## LiDAR Quality Assessment Report

**IL\_District4-mcdonough\_2014**

NGTOC  
2015-05-18  
Brent Marz

Anomaly5: sensor error or overlap present

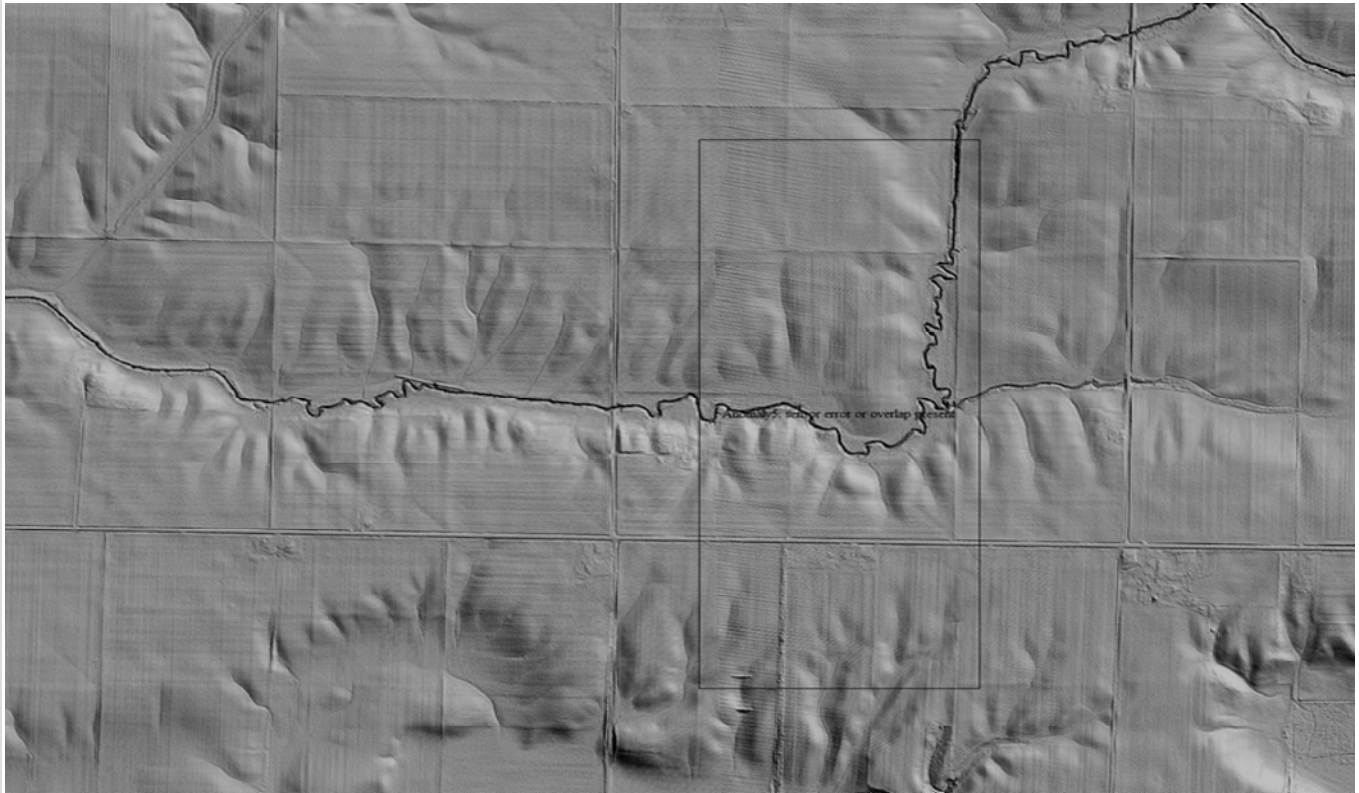
DEM errors are representative of errors in District 4 dataset.
